Donald C. Cook Nuclear Plant Units 1 and 2
QUALITY ASSURANCE PROGRAM DESCRIPTION, REVISION 16

DONALD C. COOK NUCLEAR PLANT
QUALITY ASSURANCE PROGRAM DESCRIPTION, REVISION 16

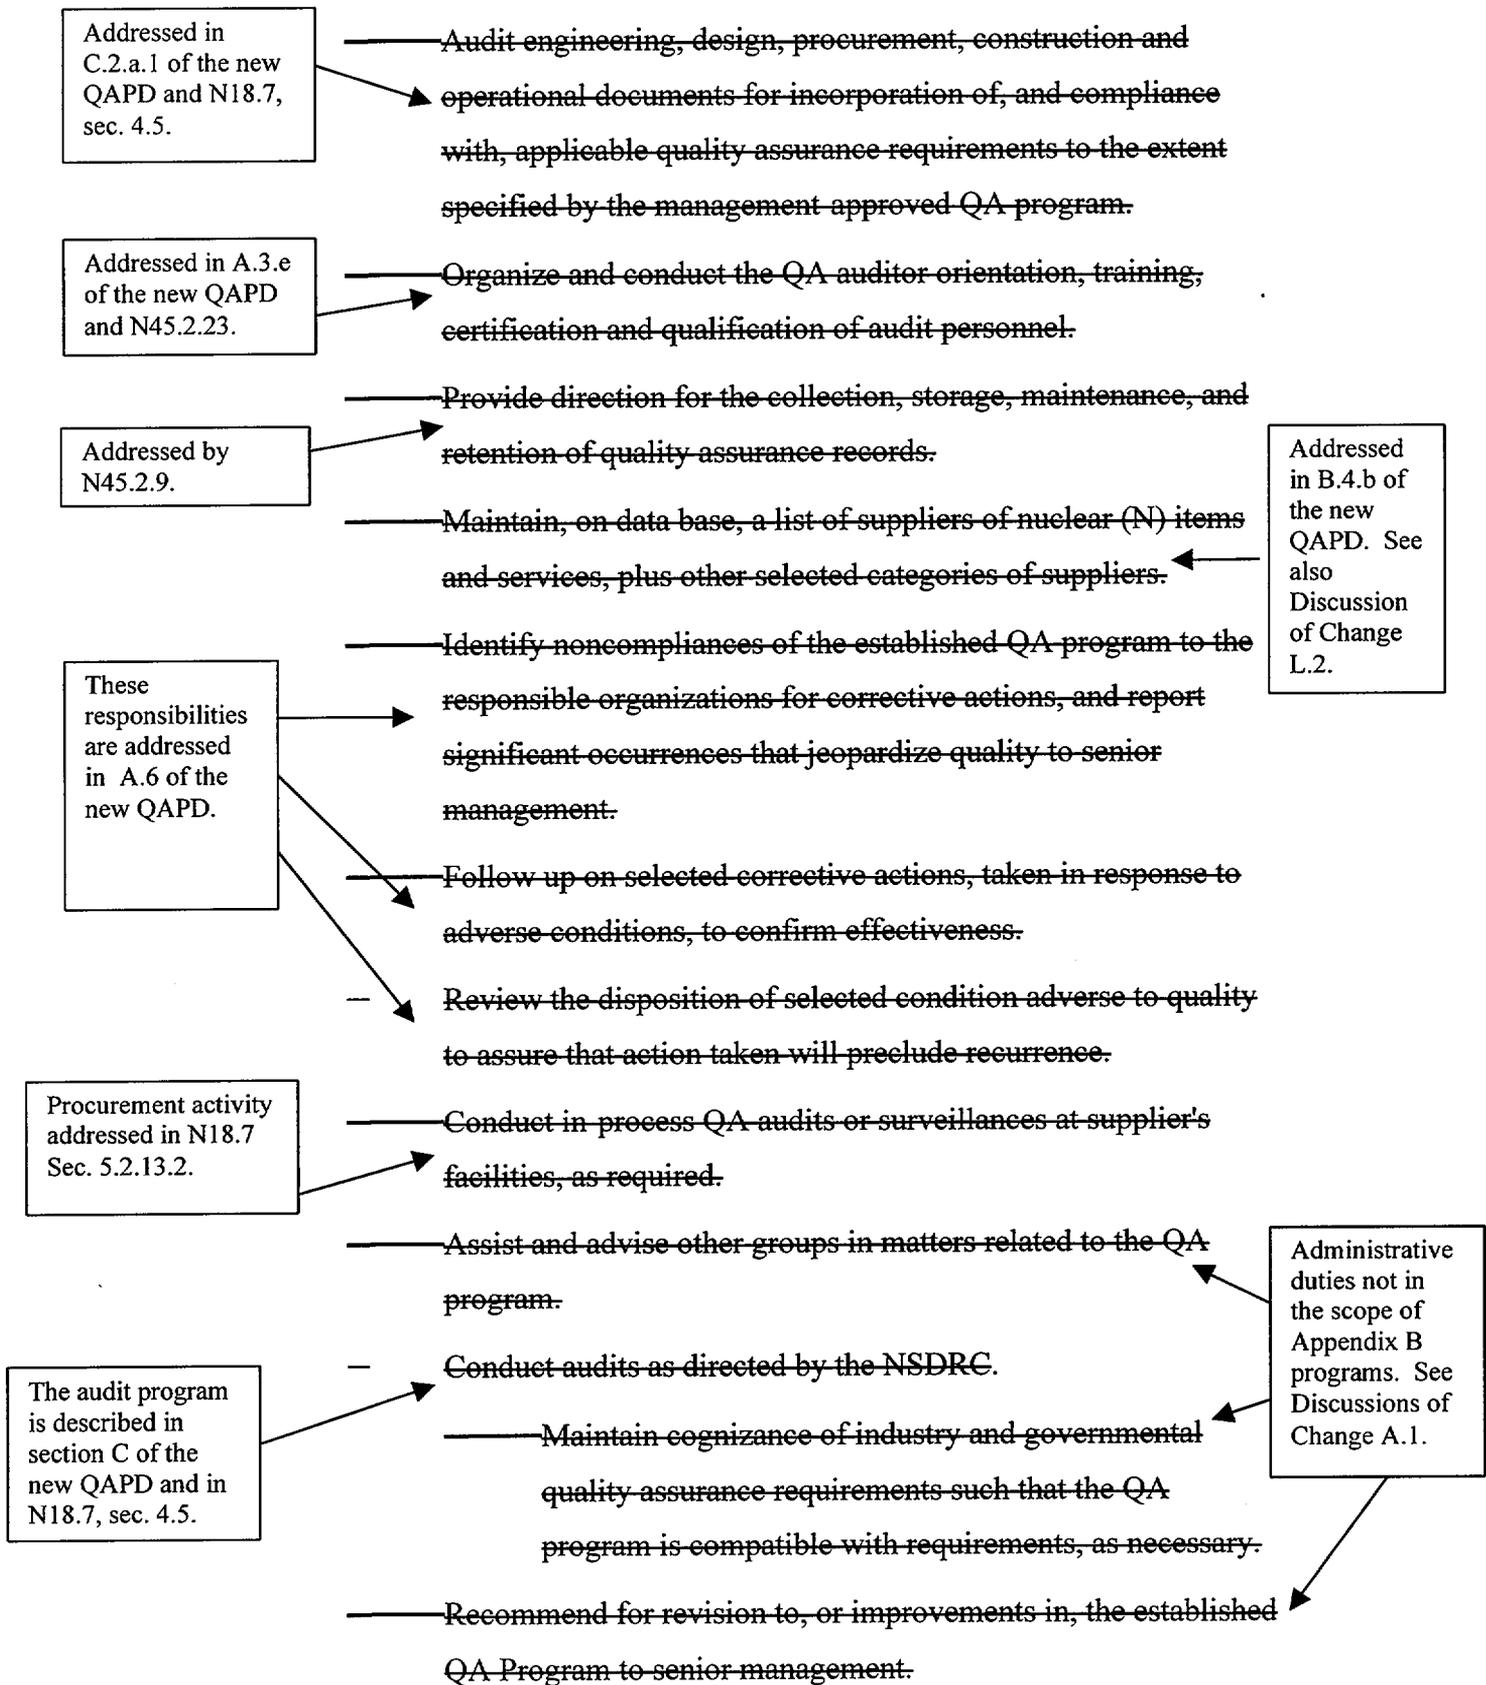
~~The performance assurance director, reporting to the chief nuclear officer (CNO) is responsible for the performance assurance organization. The performance assurance organization is shown in Figure 1.7.2.~~

This is addressed in A.2.b.1 of the new QAPD.

Figure 1.7-2

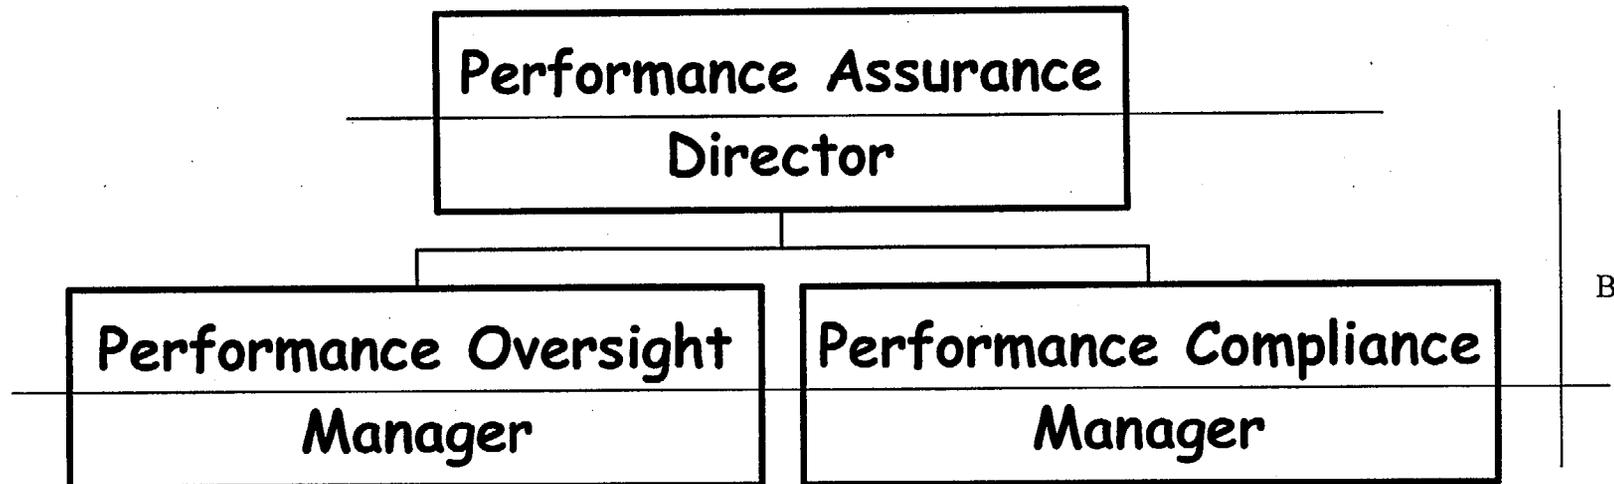
Only "operating organization positions" needs to be identified per section 6.2.1a of the Technical Specifications.
